Heritage Vaughan Committee Report

DATE: Wednesday, March 19, 2025

<u>TITLE</u>: PROPOSED DEVELOPMENT ON 239, 245, 251 WOODBRIDGE AVENUE

MASSING VIEWS

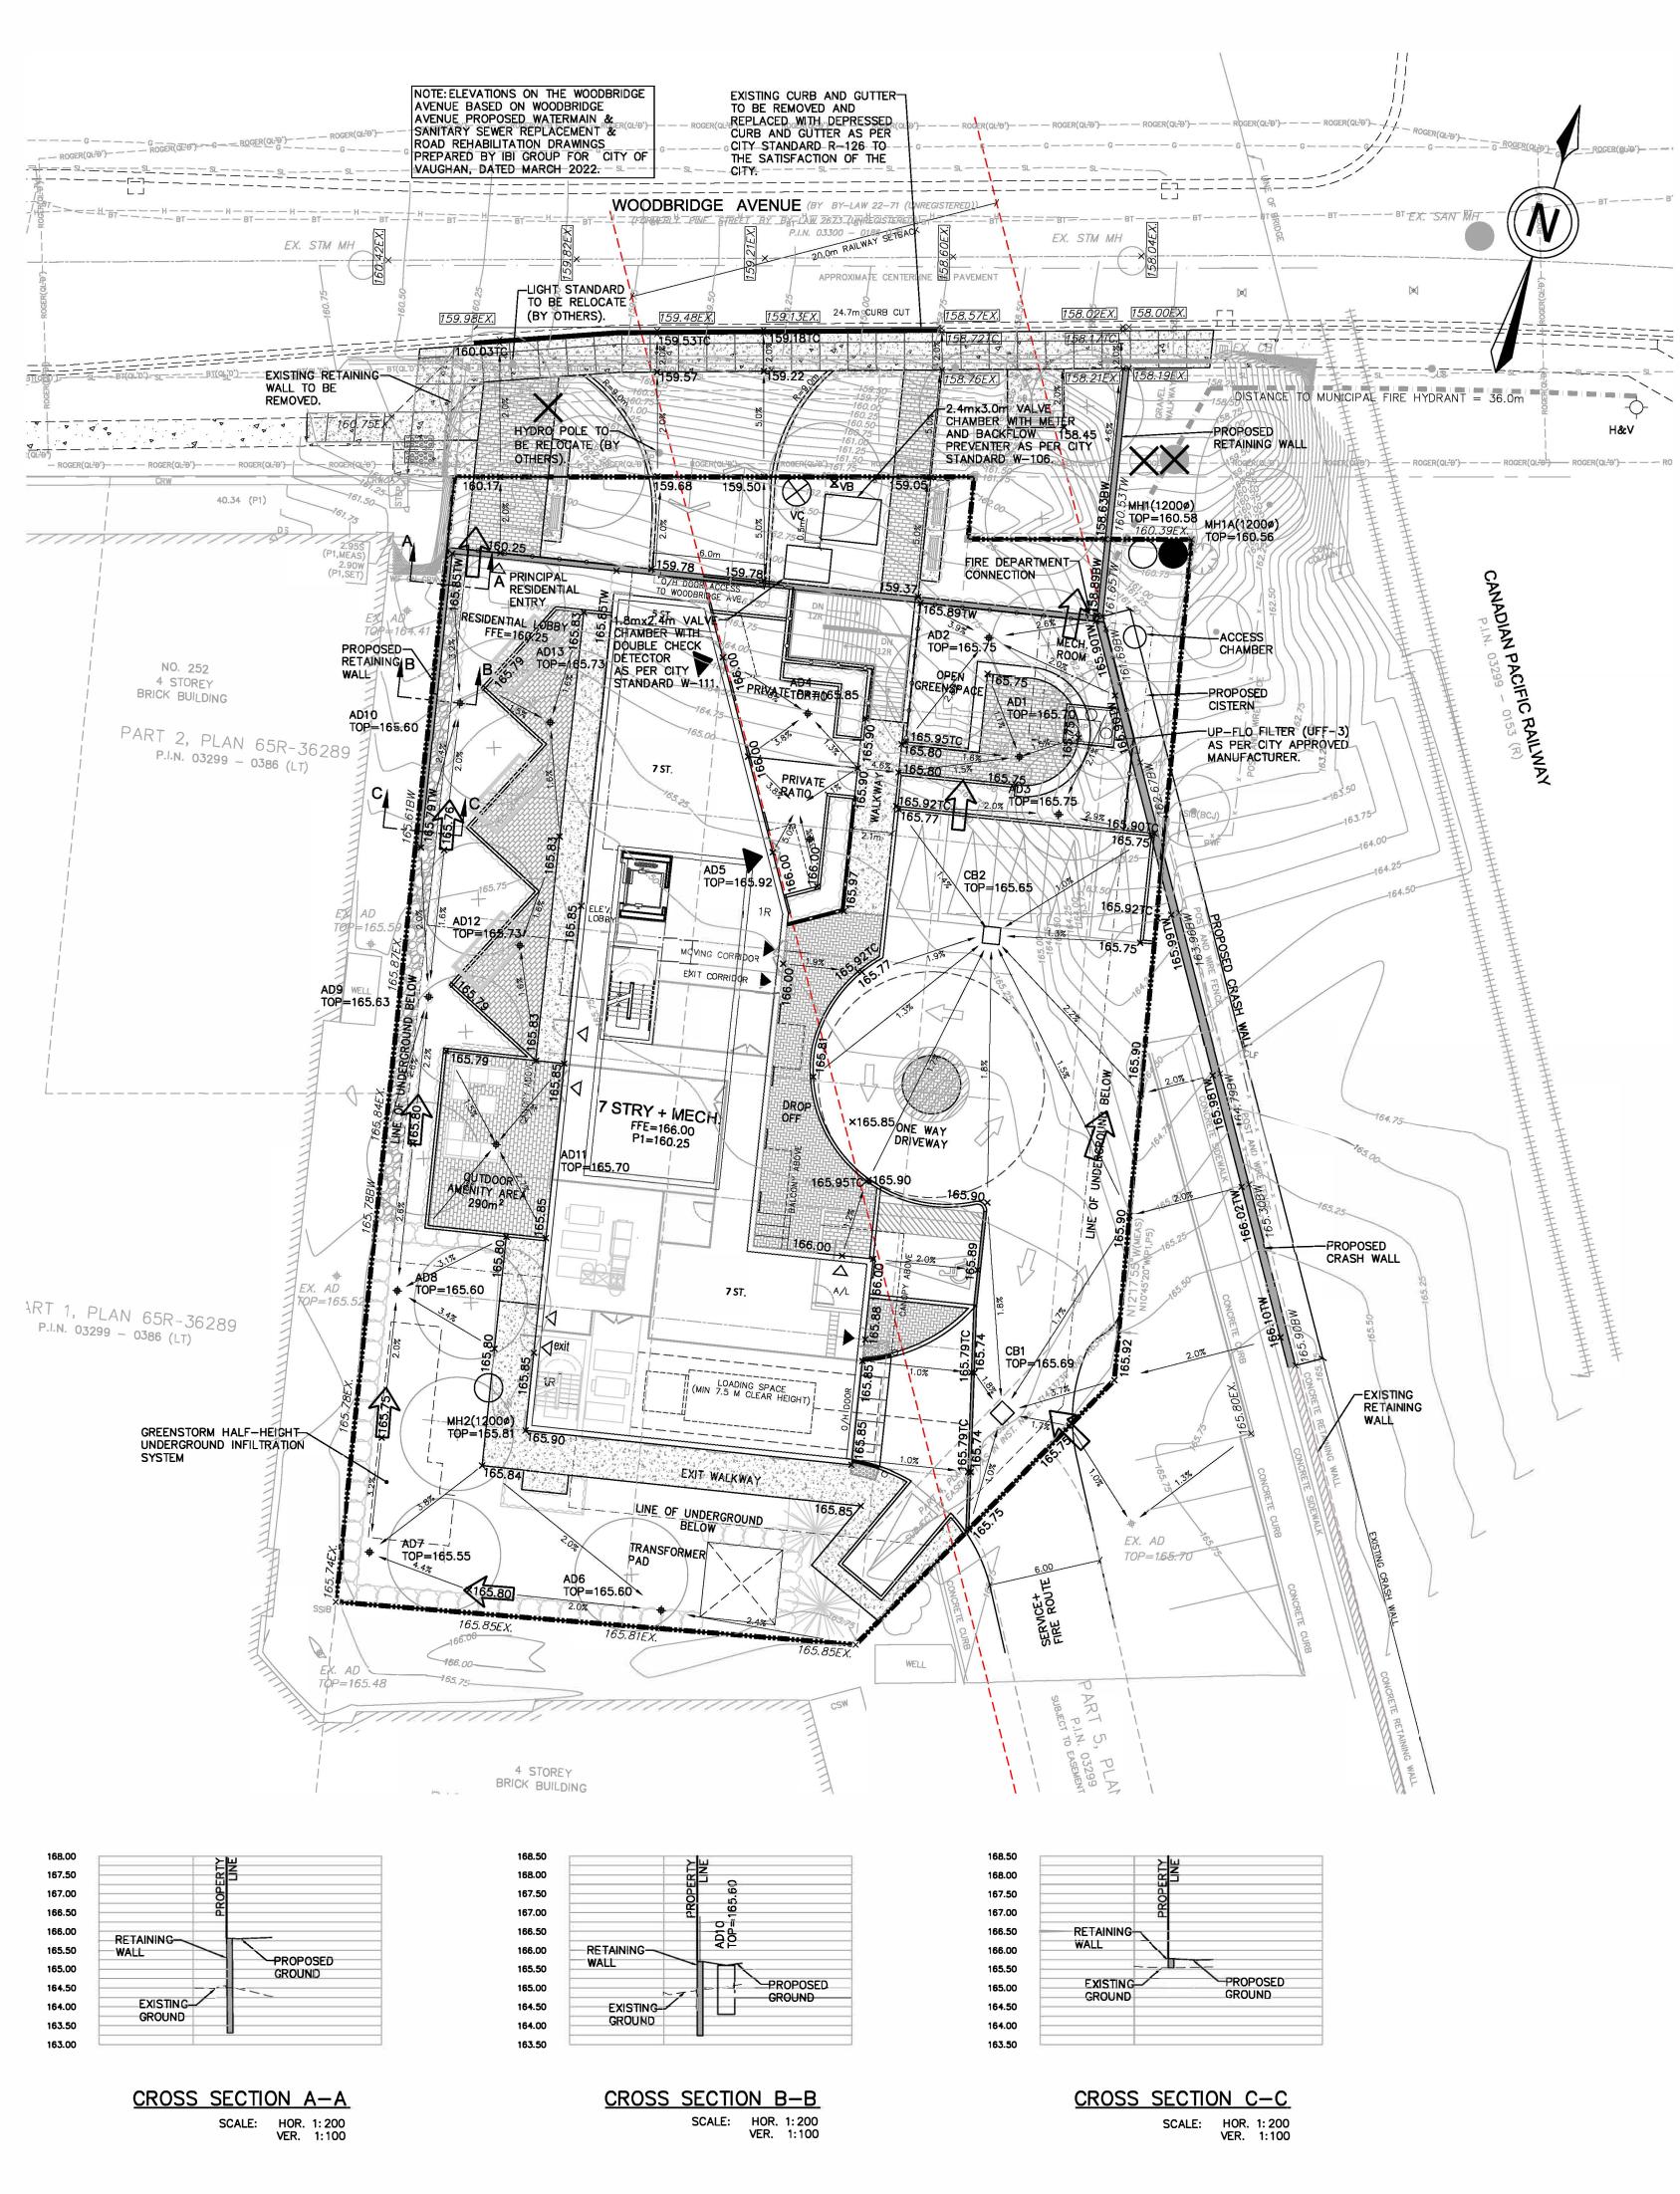
The height of the proposed development does not fully align with the WHCD Plan. According to the WHCD Plan, the height of the building is permitted up to six (6) storeys (20 m), provided there is a podium of a minimum of two (2) storeys. This proposal is for seven (7) storeys, and as seen in the architectural set (Attachment 4), is set at a height of 24.8 metres, with the podium only appearing as one (1) storey. The applicant submitted CHIA states that "it is recommended that the proposed building not be taller than the existing building to the west in order to provide a better transition to the railway, landscape and buildings to the east".

While the proposed development does not meet the requirements of height according to the WHCD, City Cultural Heritage and Planning staff and the property owner(s) agreed that the original height of 25.8m be brought down to 24.8m to match the building directly across the street in order to match the massing on the streetscape.

1. THAT Heritage Vaughan recommend that Council approve the development as proposed at 239, 245, 251 Woodbridge Avenue under Section 42 of the *Ontario Heritage Act*, subject to the following conditions:
